## PRODUCT/PROCESS CHANGE NOTICE (PCN)

<b>PCN #:</b> TB-0510-05 <b>DATE:</b> 14-Dec-2005 <b>Product Affected:</b> 48L, 56L, 64L TSSOP & 80L TVSOP & 48L, 56L TSSOP exposed pad (Green & Standard) <b>Date Effective:</b> 13-Jan-2006	<b>MEANS OF DISTINGUISHING CHANGED DEVICES:</b> <input type="checkbox"/> Product Mark <input type="checkbox"/> Back Mark <input type="checkbox"/> Date Code <input checked="" type="checkbox"/> Other      Rev 07 printed on shipping tube
---	--

### ATTACHMENT I - PCN #: TB-0510-05

#### New Shipping Tube

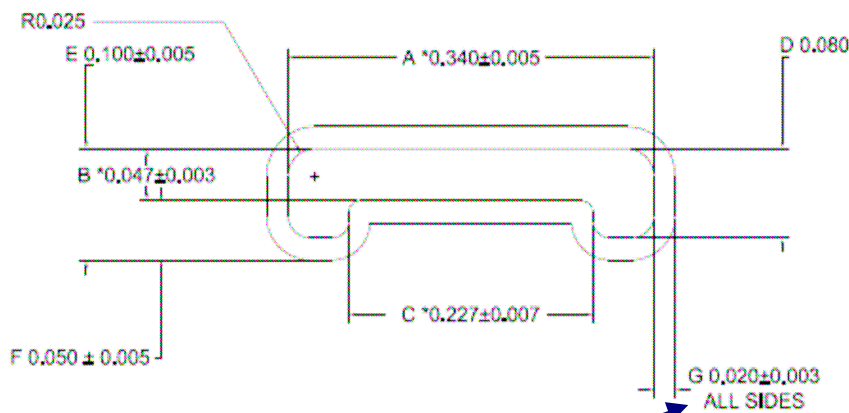
**Detail of Change:** This change is to increase the shipping tube's wall thickness in order to provide better protection to the packages during assembly, test and back-end processes. The changed shipping tube will be printed with Rev. 07 as shown in the detailed drawing.

Description	Existing Tube	New Tube
Wall Thickness (inch)	0.015 - 0.020	0.017 - 0.023
Revision Printed on Tube	Rev. 06	Rev. 07

Existing Tube – wall thickness : 0.015 to 0.020

Existing Tube – printed revision, REV.06

New Tube – wall thickness : 0.017 to 0.023

New Tube – printed revision, REV.07
